**A RESOLUTION OF THE CITY OF GRAND PRAIRIE, TEXAS,  
APPROVING THE CITY OF GRAND PRAIRIE'S CITY-WIDE  
DRAINAGE MASTER PLAN FOR CEDAR CREEK.**

# City of Grand Prairie City-wide Drainage Master Plan for Cedar Creek (Y#0845)

**AECOM TECHNICAL SERVICES, INC.  
16000 Dallas Parkway  
Suite 350  
Dallas, Texas 75248  
TBPE Reg. No. F-3580**

**August 2011**

FIGURE 8 - Drainage Master Plan for Cedar Creek: Ultimate Conditions

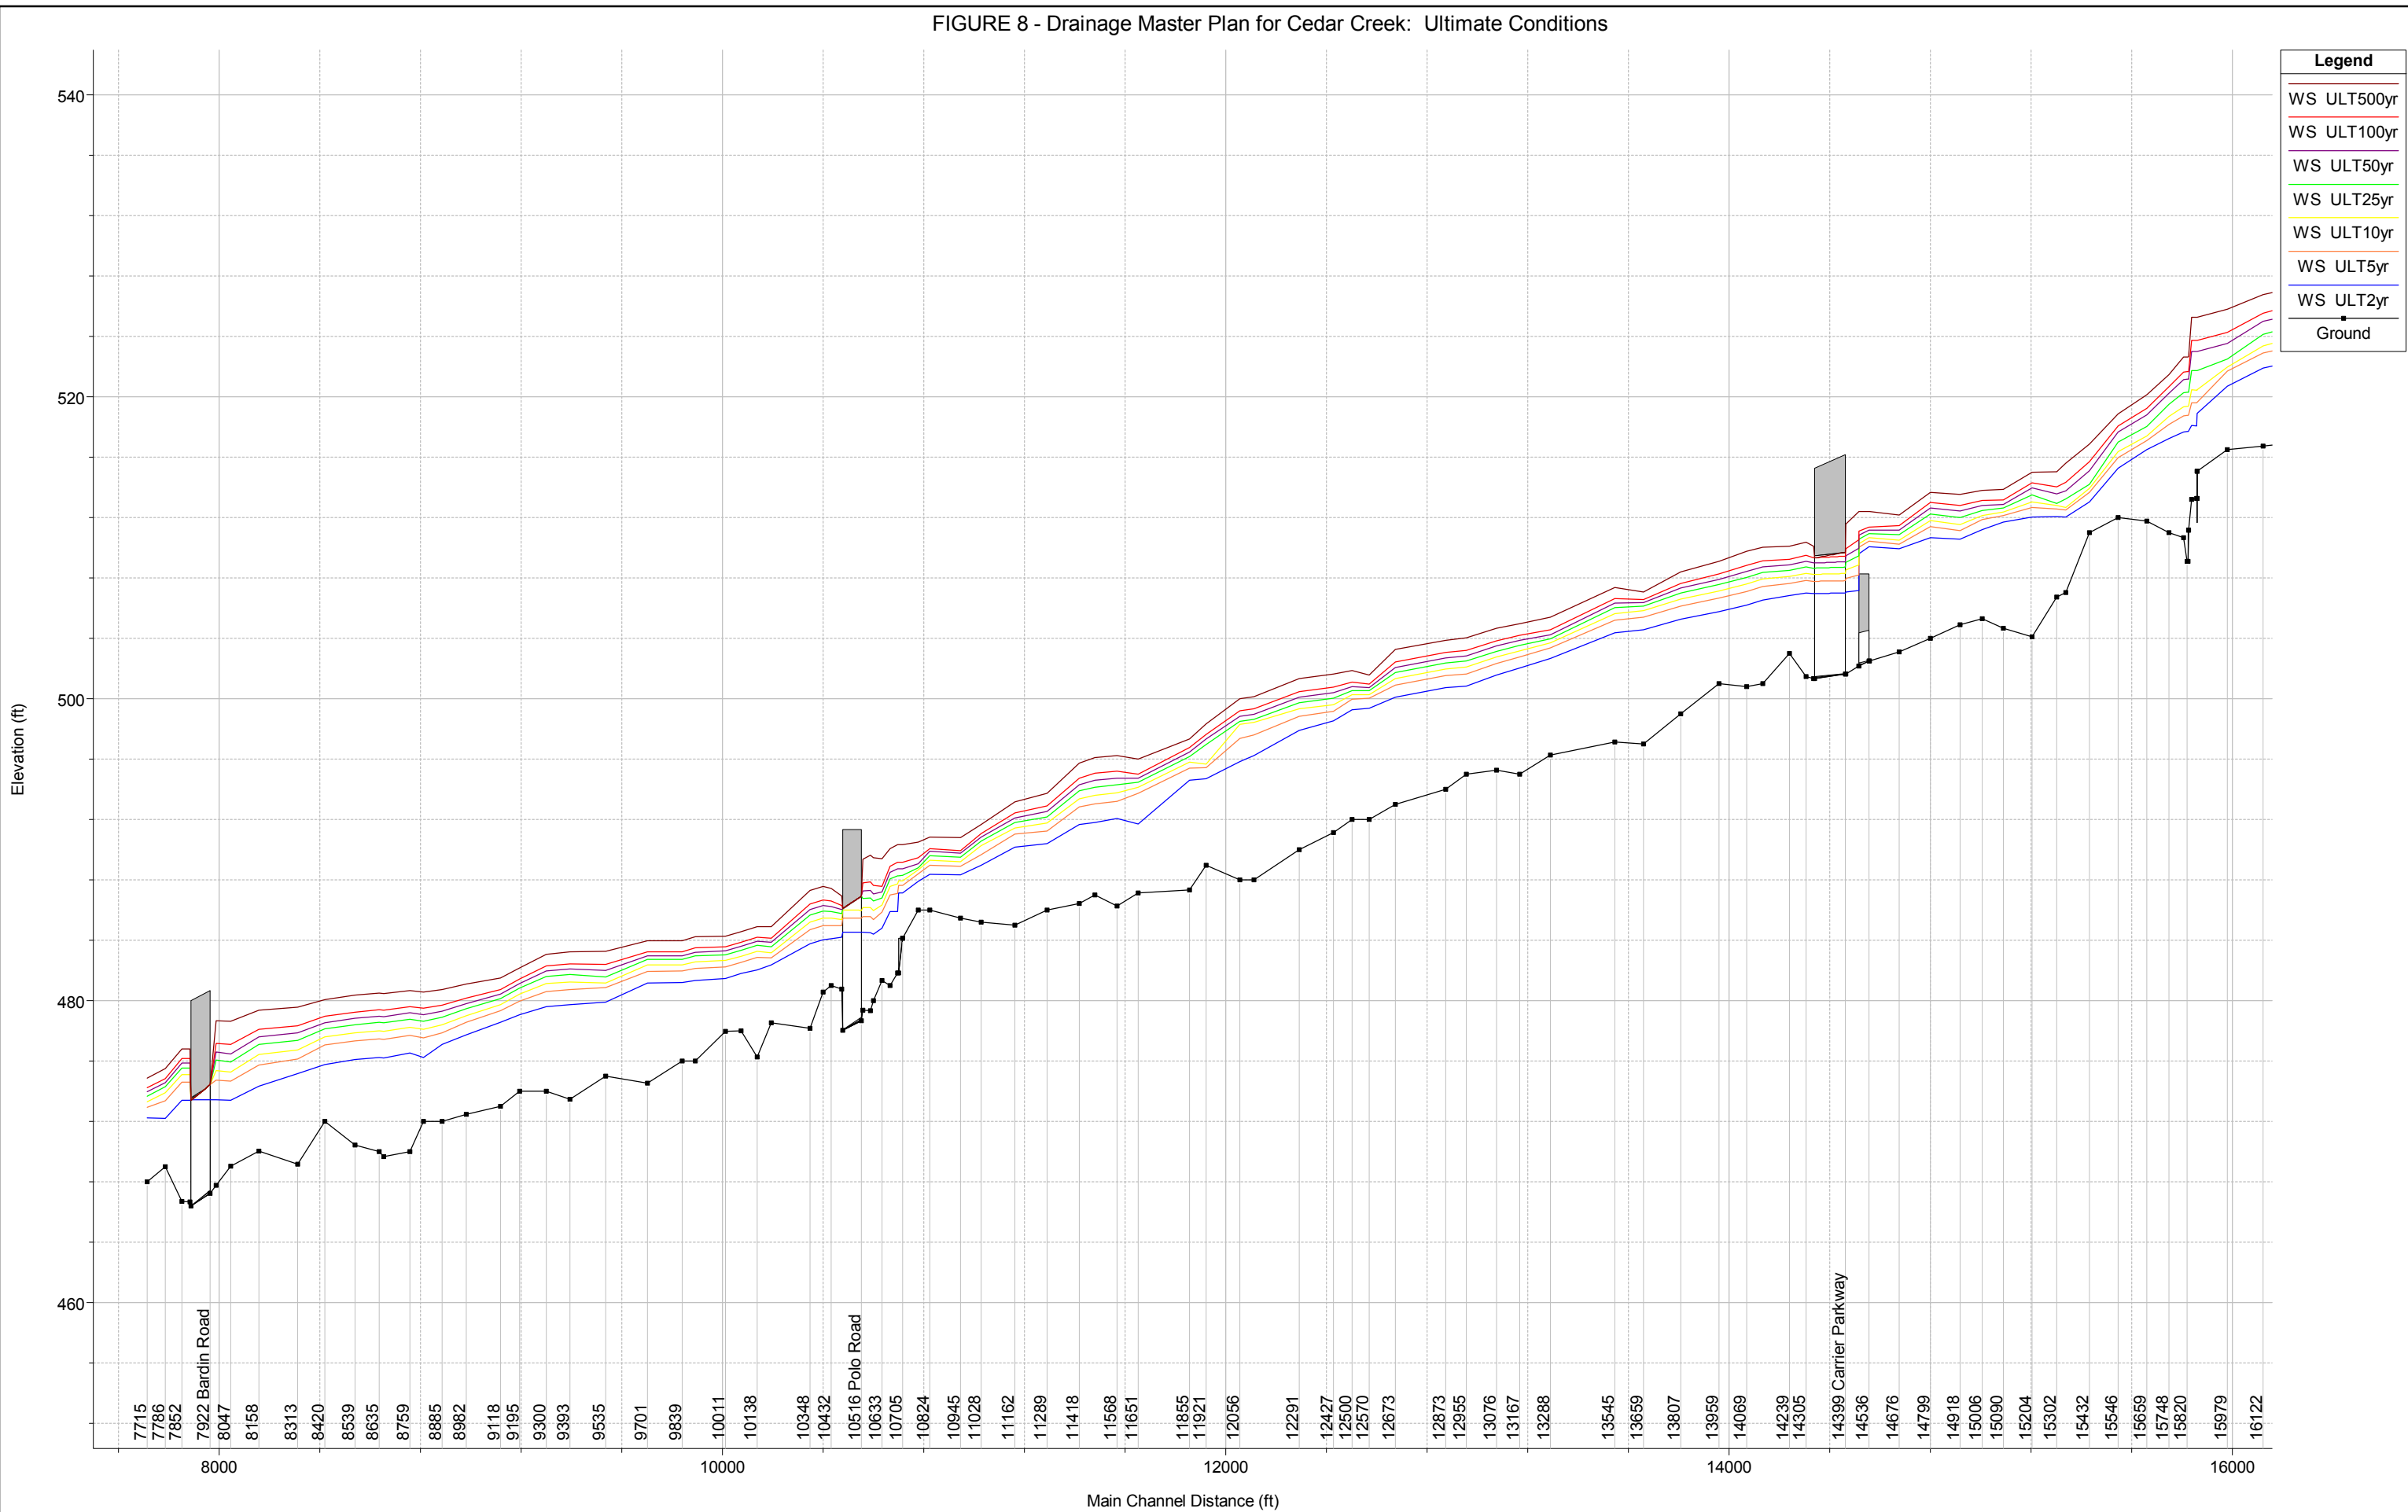
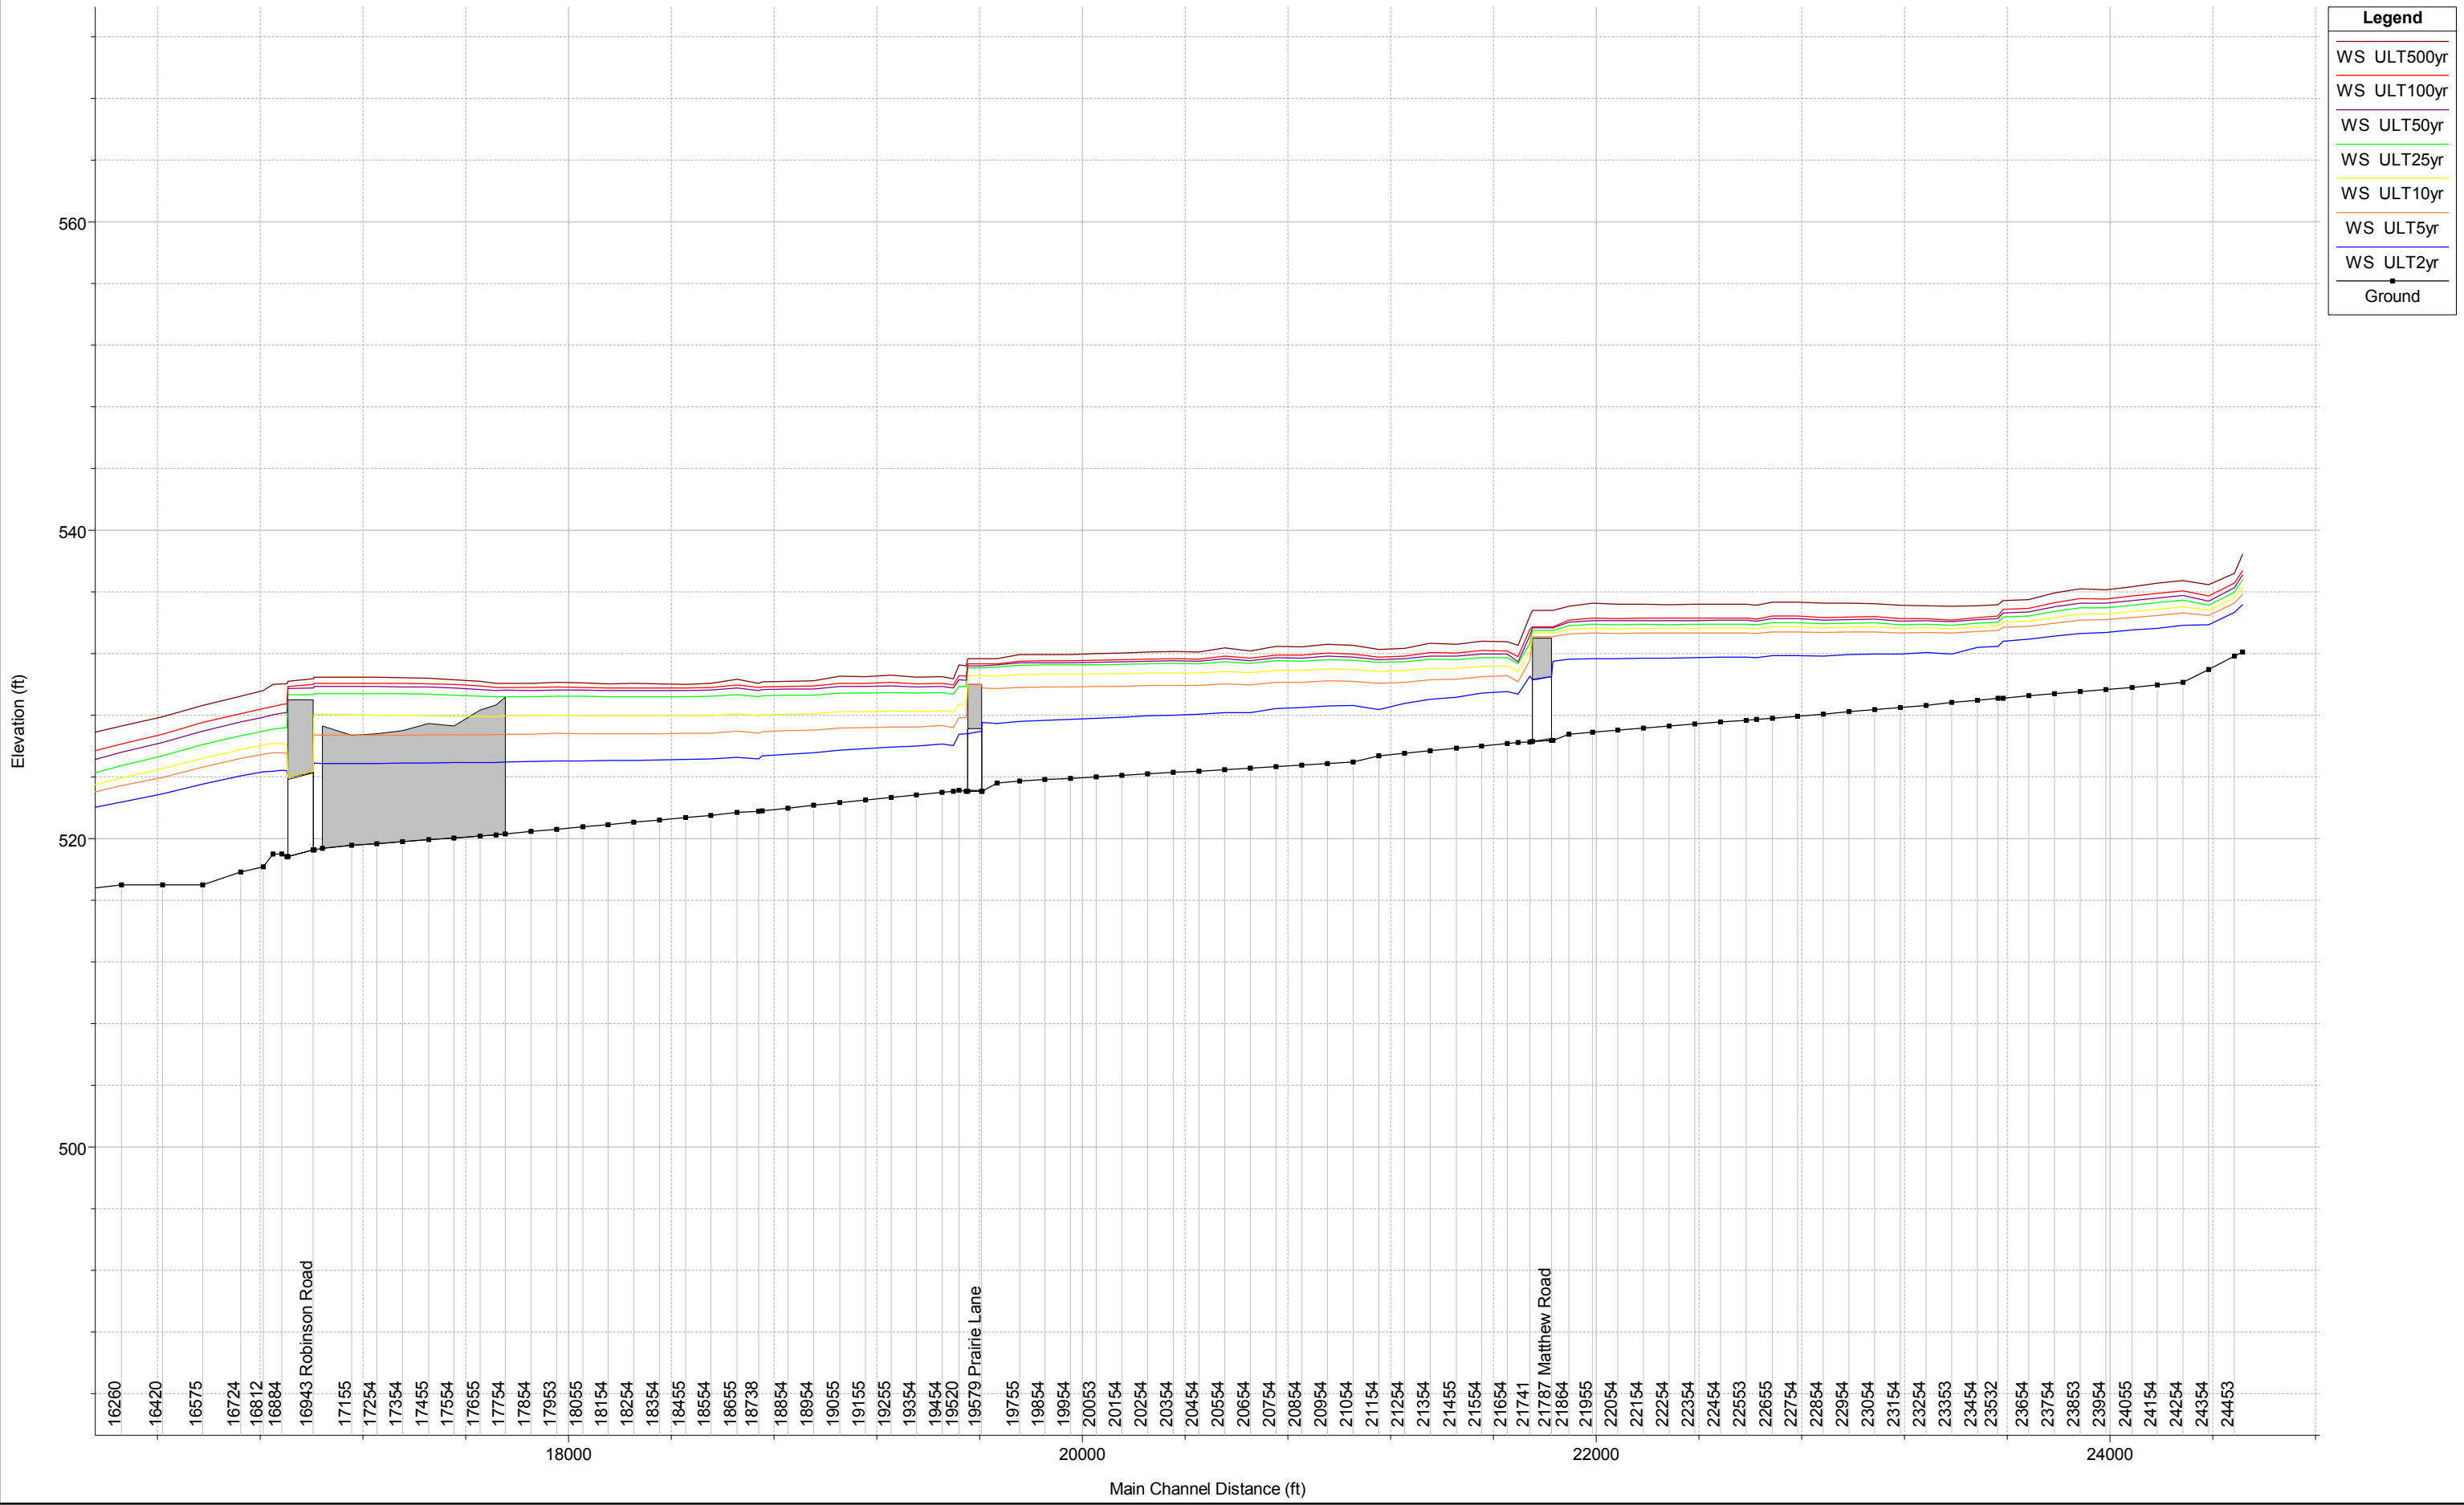
18. *Appendix A – Ensure that the flood profiles for existing and ultimate conditions are labeled as Figure 7 and Figure 8, respectively.*
